ADDENDUM #3

August 27, 2025

**CRAWFORDSVILLE READINESS CENTER MODERNIZATION
INDIANA NATIONAL GUARD
CRAWFORDSVILLE, INDIANA**

IFB NO: MDI-SAB-26-B-013

ABI 1
A350

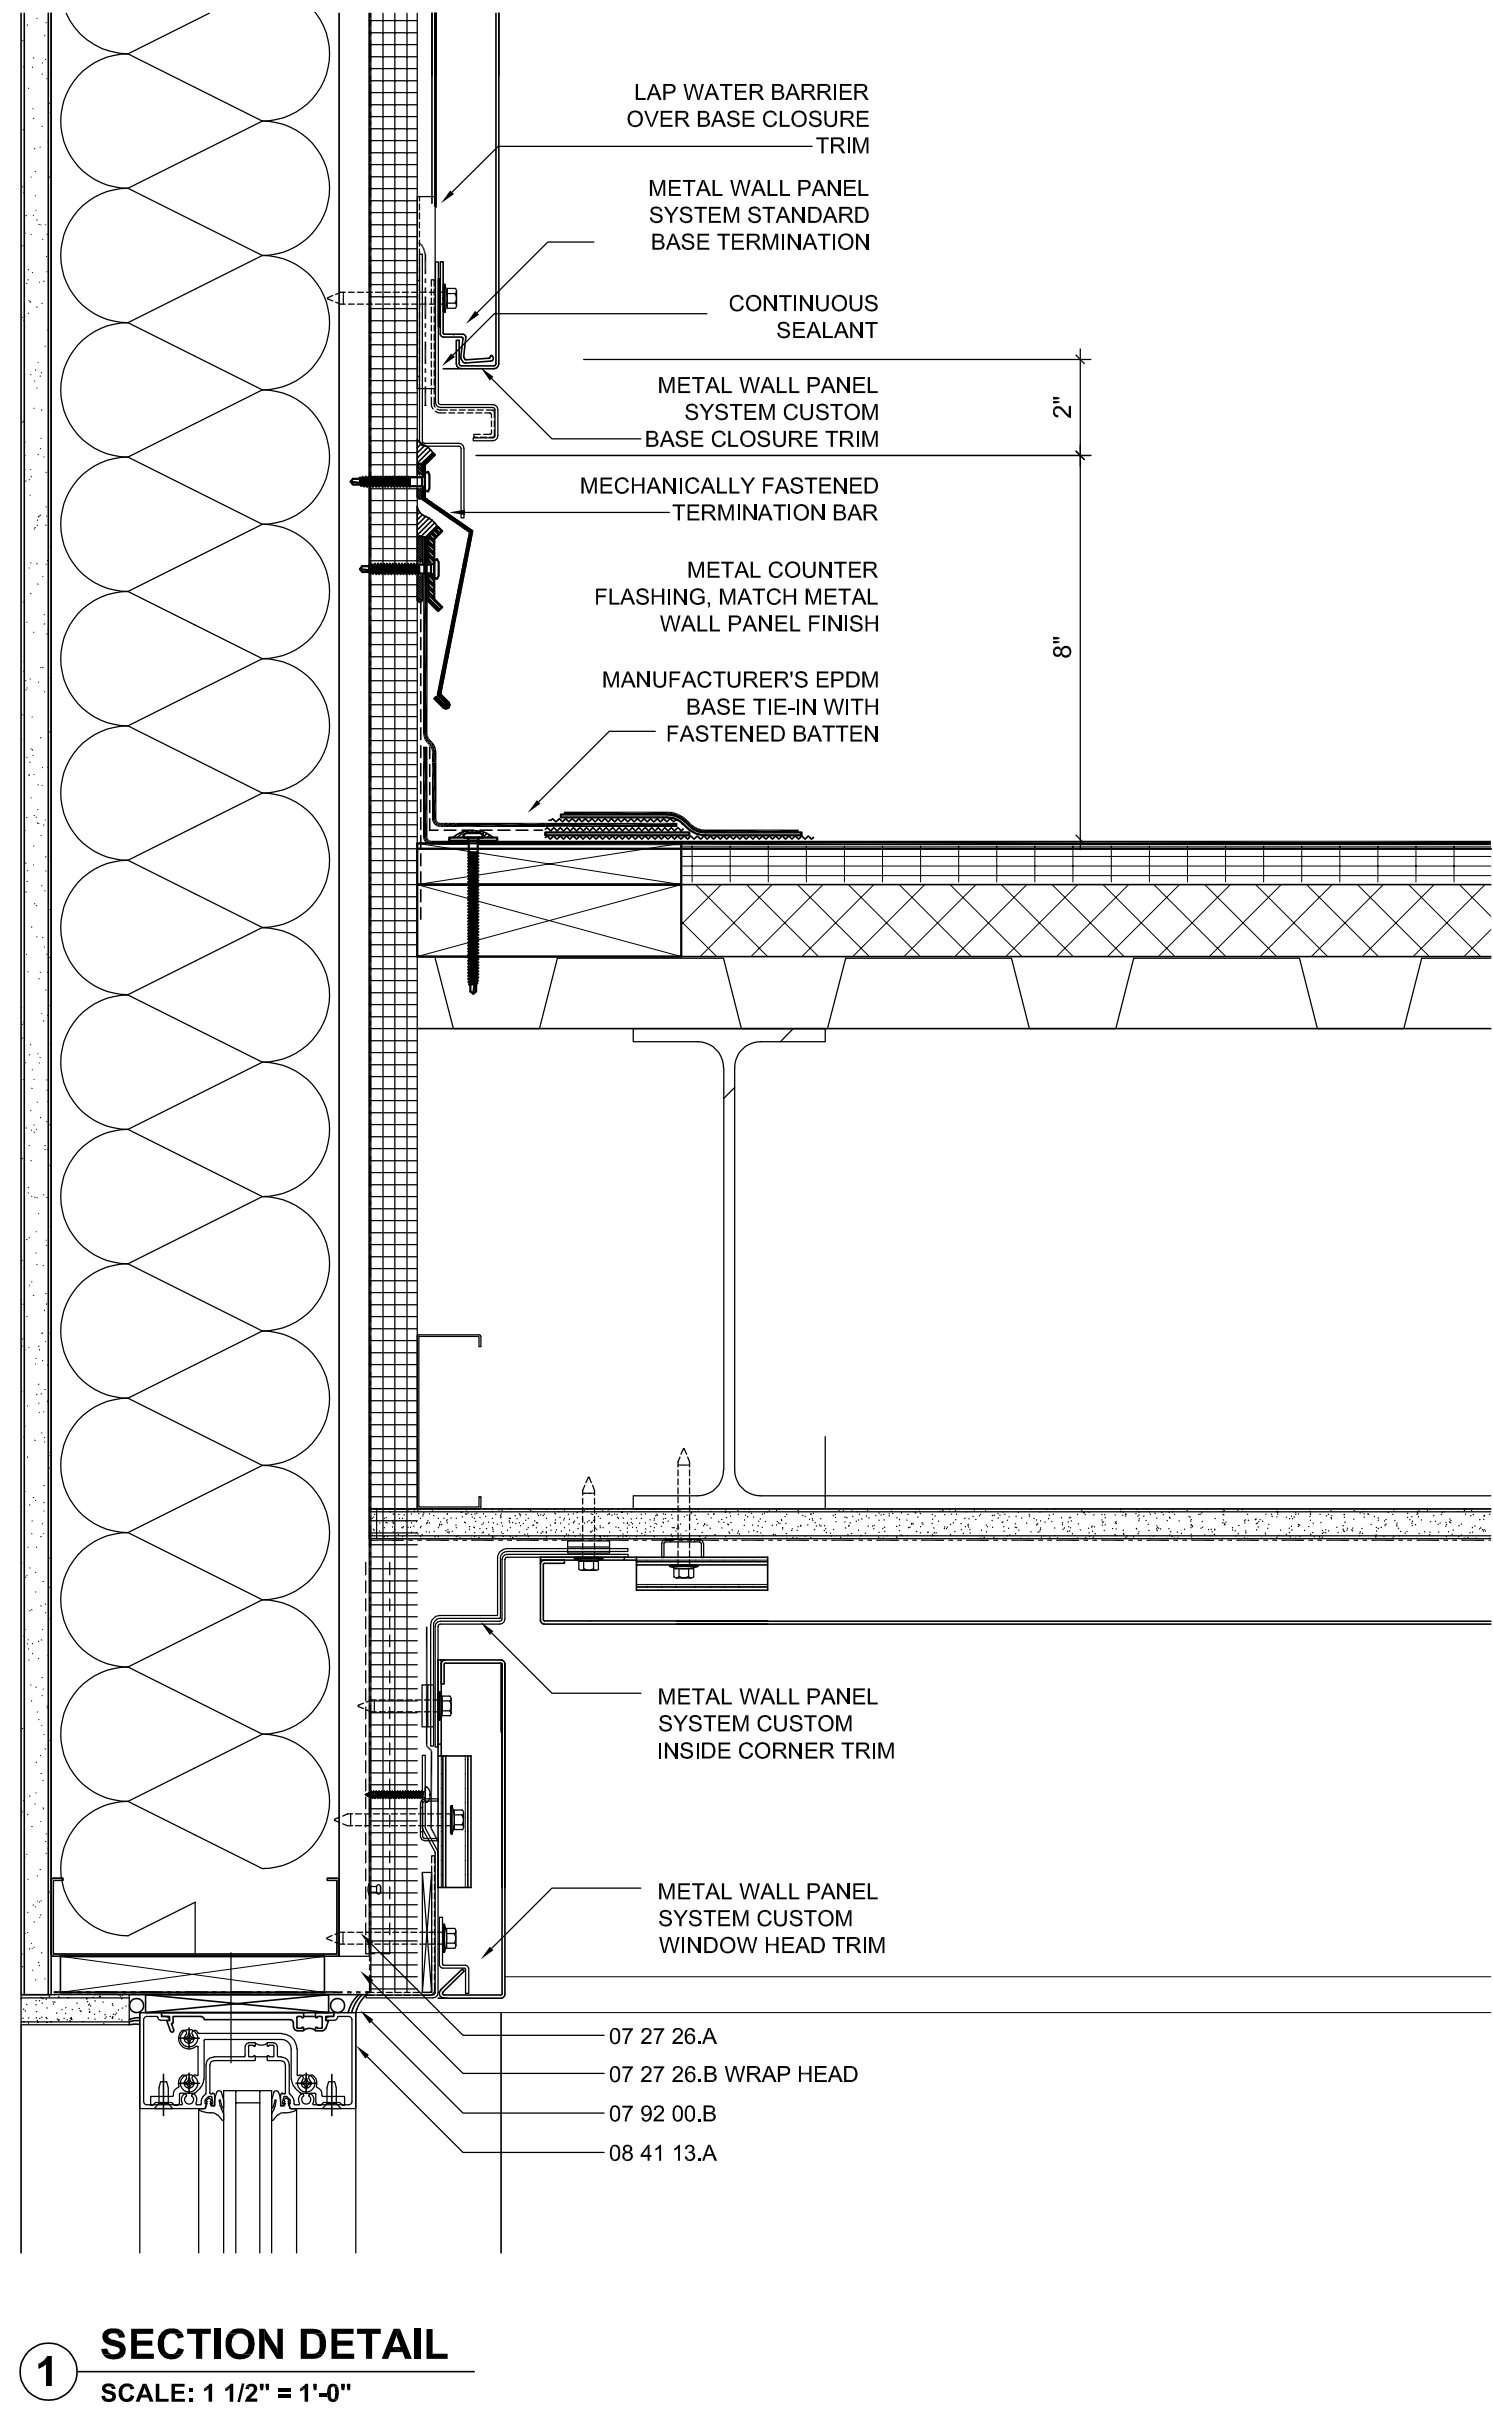
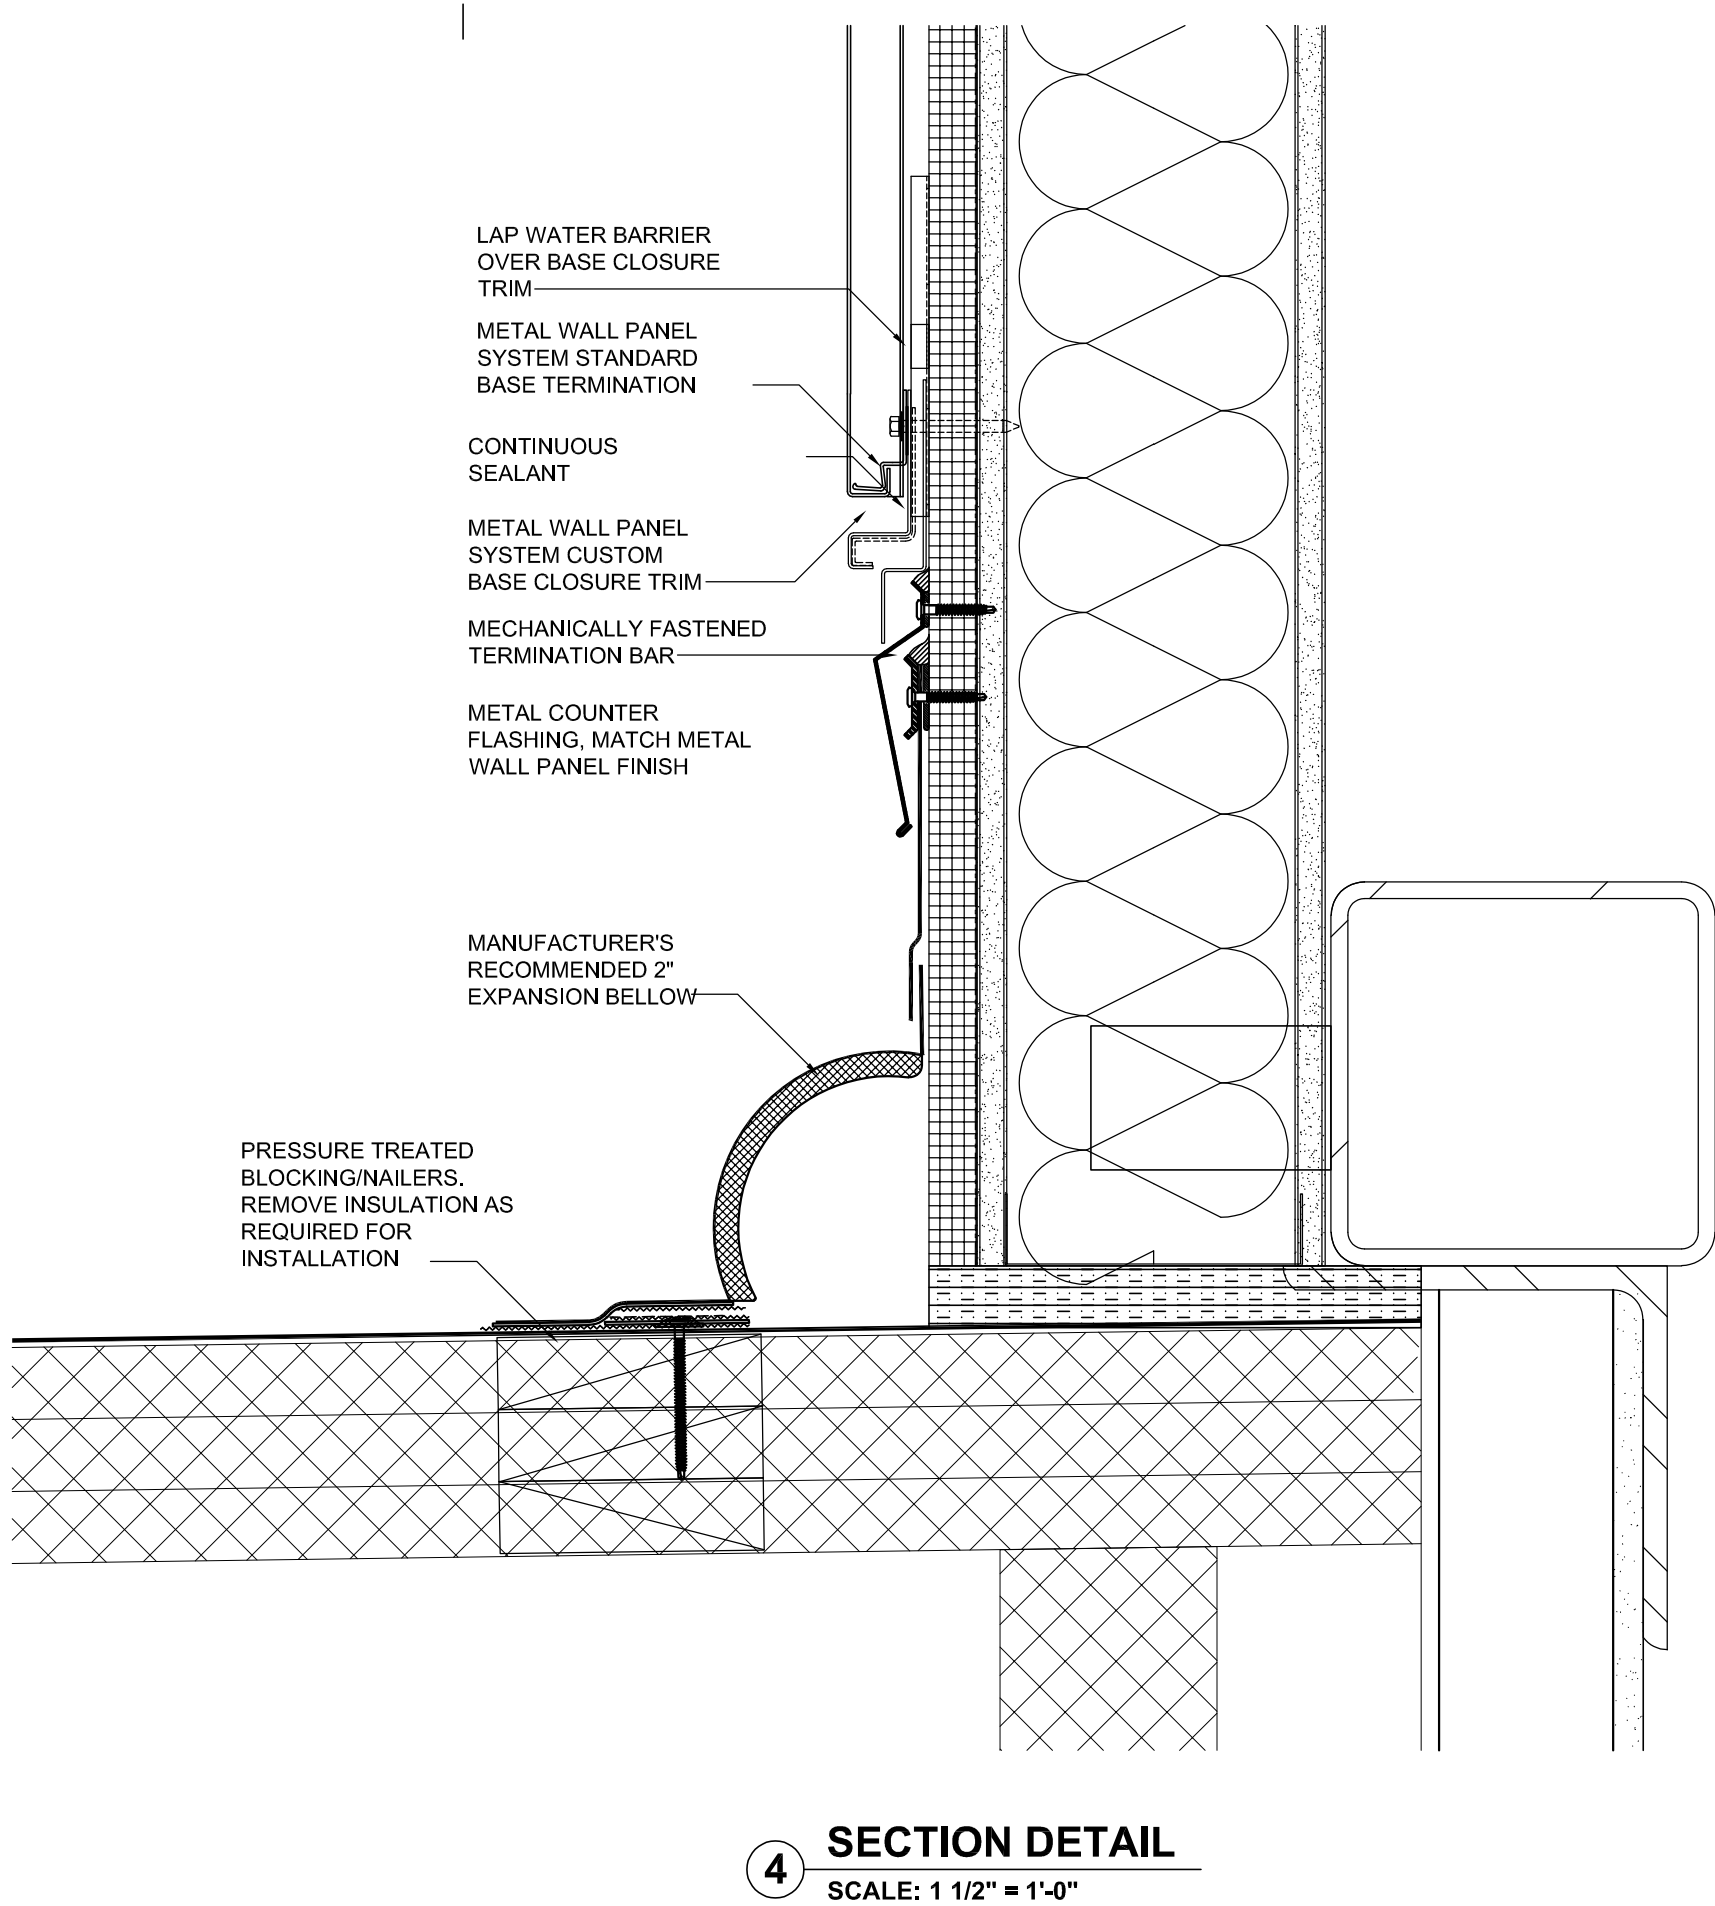
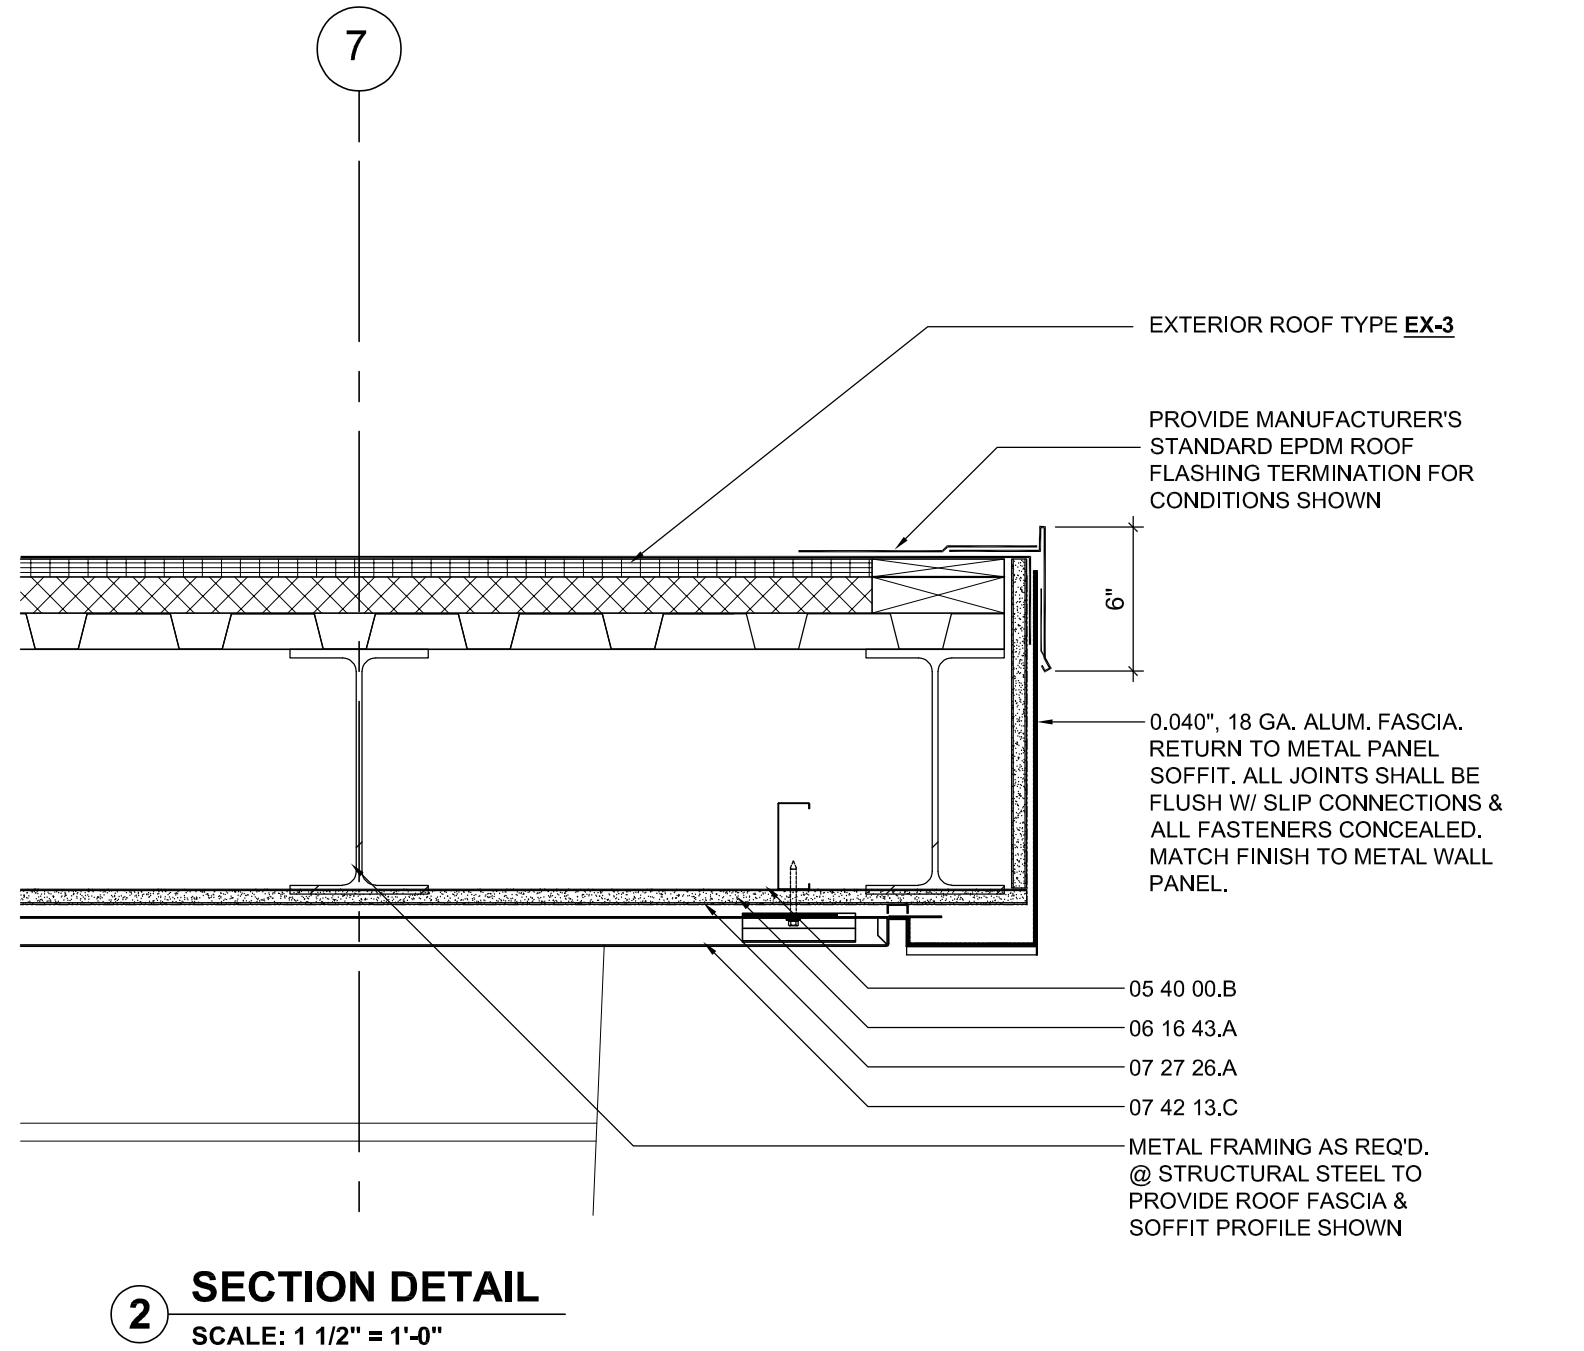
- 14. Sheet ABI 1 A350 – ABI 1 PLAN DETAILS
 - a. Revised Details 4 and 7
- 15. Sheets ABI 1 A360 – ABI 1 SECTION DETAILS
 - a. Add sheet to the Project
- 16. Sheet ABI 1 A802 – ABI 1 INTERIOR ELEVATIONS

15. **Question:** Section 07 95 00 Expansion Control lists model VF Series by Construction Specialties, however details 1/A350 and 6/A350 show SF Series by Construction Specialties. Should we bid per the details?

- Response:** More than one expansion joint style is required. Bid per the details.
17. **Question:** On ABI1 A110, it appears that Vestibule 100 has a drywall ceiling in there, but there is no tag saying what that ceiling is supposed to be. Please confirm this to be a drywall ceiling?
